- CONCEPTUAL -
FOR REVIEW/DISCUSSION

CAPITOL CORRIDOR
UNION PACIFIC

DRAWN BY: BPK	CAPITOL CORRIDOR JOINT POWERS AUTHORITY
CHECKED BY: WGS	LOCATION: ROSEVILLE, CA MP 98.70 - MP 106.60 MARTINEZ SUBDIVISION
DATE: 04/06/2017	
SHEET NUMBER 003 of 003	DWG TITLE: 3rd MAIN TRACK PROJECT RAIL CONCEPTUAL LAYOUT - PHASE 1

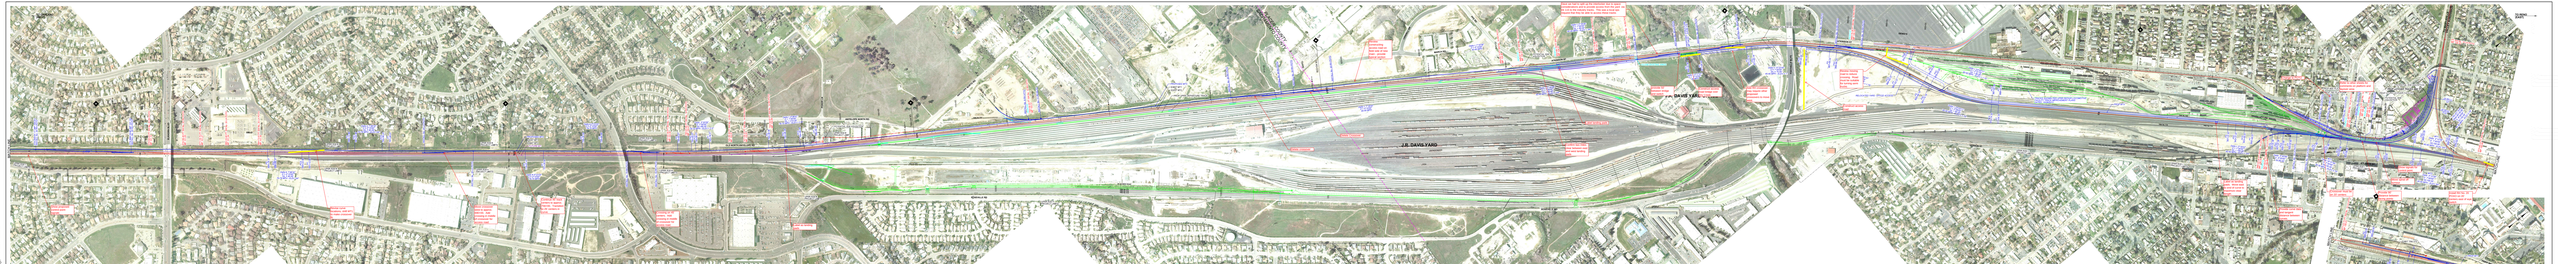
Show proposed control point signals

Revise curve locations, shift MT1 to make crossover fit.

Move crossover west to approx. 690+00. Add crossing in middle of crossover for access road.

Continue 45' track centers to approx. 756+00. Transition to 25' centers in curve.

Crossing on 45' centers. Add crossing in middle of crossover for access road.

Label as landing pads

Review constructing access road on field side of new main - provide typical section

Delete crossover

Delete Crossover

Confirm two miles clear between east and west landing pads

Label landing pads

Dave we had to split up the interlocker due to space considerations and to provide access from the yard via trk 115 to the industry tracks. This was a local ops request that they be able to access these tracks

provide 50' between bridge and switch

Construct access road bridge over Dry Creek

Add RH crossover may require other proposed crossovers to move west.

Review moving road to reduce crossing. Road must be suitable for turning semi trucks

Construct access road

Change to POTO

Refer to other sheets for comments on platform and layover area

Label as landing pads. Move east to end of curve to maximize clear length.

Provide curve data and tangent distance between curves.

Crossover must be on 20' centers

Provide 90' distance between facing points

Move spiral off turnout

Show signals for control point

Install RH No. 20 POXO on 20' centers east of wye switch
